EXECUTIVE SUMMARY

The purpose of this report is to present Council with information, analysis and recommendations for a Development Permit with Variances Application for the property located at 780-798 Fort Street and 1106-1126 Blanshard Street. The proposal is to construct a 20-storey hotel with office and ground floor commercial uses and to heritage designate and upgrade the existing, three-storey Montrose Apartments. The variances are related to an increase in height and a reduced side-yard setback.

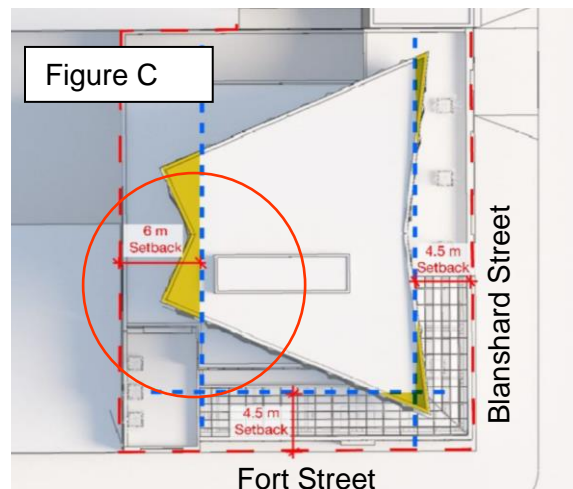
The proposal provides a 4.5m setback above the third storey and maintains this consistent setback to the top of the building. This results in a narrower building closer to the street, directly above the podium which creates a complementary podium height to the Montrose Apartments and increases views to St. Andrew’s Church to the north. The benefits gained by reducing the height of the podium is illustrated in Figure B (below) which shows how building setbacks consistent with DCAP (shown on the left) diminish views to the church.
